# **Safety Evaluation Report Related to Disposal of High-Level Radioactive Wastes in a Geologic Repository at Yucca Mountain, Nevada**

Volume 3:  
Repository Safety After  
Permanent Closure

**Figure 6-1. Potential Flow Pathways in the Engineered Barrier System (SAR Figure 2.3.7-8; DOE, 2008ab)**

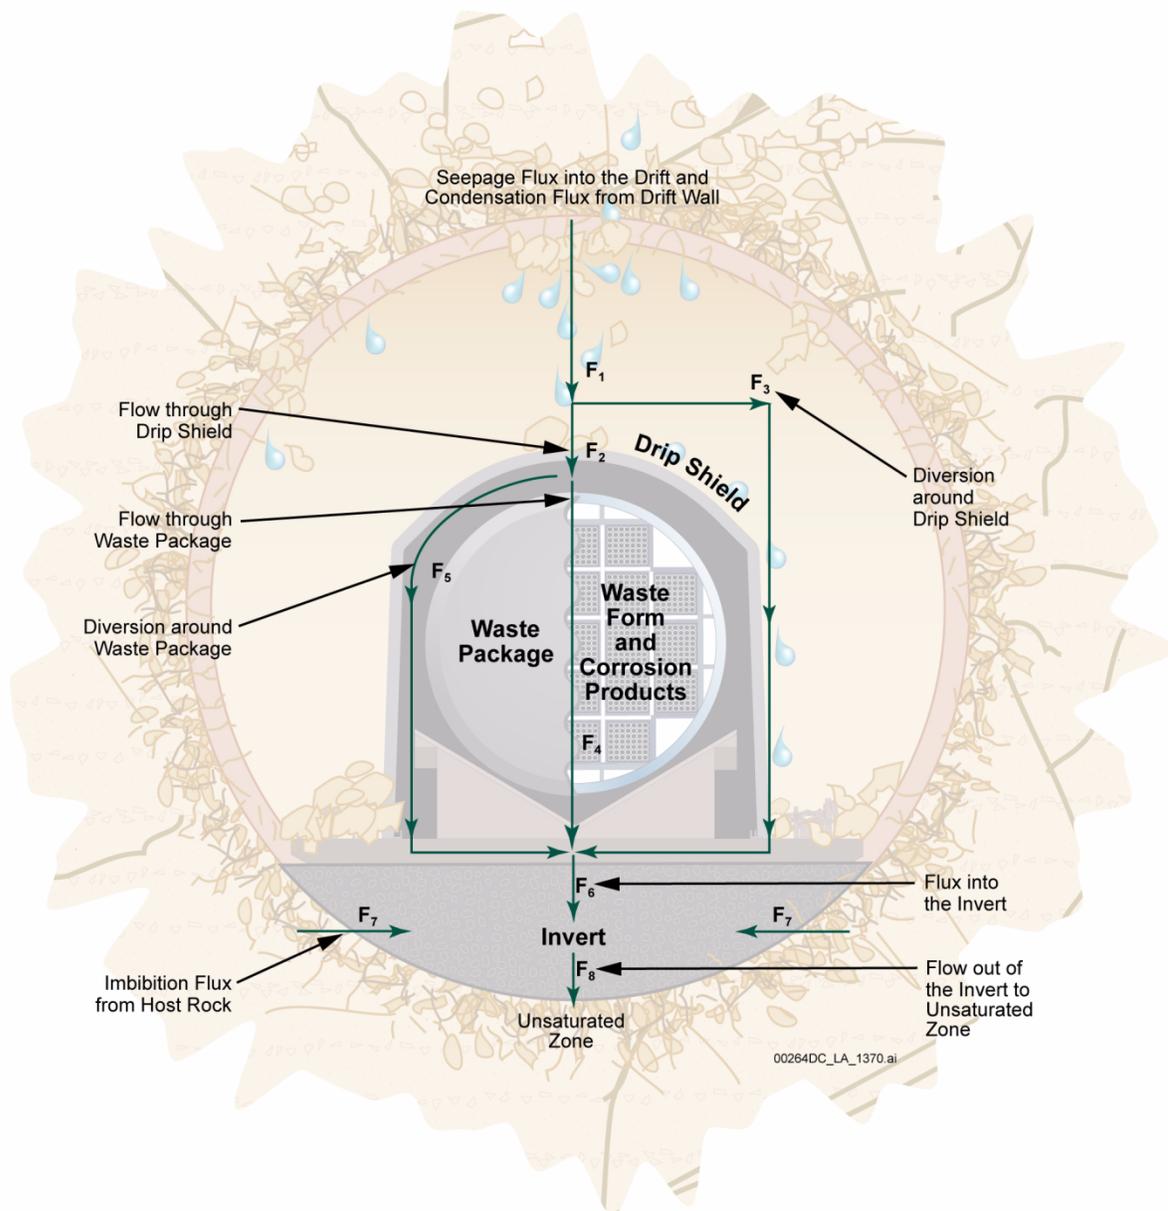
The applicant described the flow pathways and flux rates (F1–F8) in the EBS flow abstraction as follows (Figure 6-1): the F1 flow path accounts for the total dripping flux from a drift wall. The total dripping flux is the sum of the seepage flux from the drift wall above and the condensed water on drift walls (SER Section 2.2.1.3.6.3.4); these are direct inputs to the EBS flow abstraction. The F2 flow path accounts for the flux through partially failed patches of the drip shield formed by general corrosion. Localized corrosion of the drip shield is excluded from the performance assessment, as discussed in SER Section 2.2.1.2.1.3. The F3 flow path accounts for the diversion of flux around the drip shield (computed as  $F3 = F1 - F2$ ), which will drain directly into the invert. Although the diversion of flux around the drip shield is included in the construction of the EBS flow model, the applicant did not implement the flux-splitting algorithm for drip shields in TSPA simulations, because the drip shields were modeled to be either all intact or failed, as described in SNL (2007aj, Section 6.1.1). The F4 flow path accounts for the flux through patches, formed as a result of general corrosion of the outer barrier of the waste packages. Localized corrosion of the outer barrier of waste packages is not considered
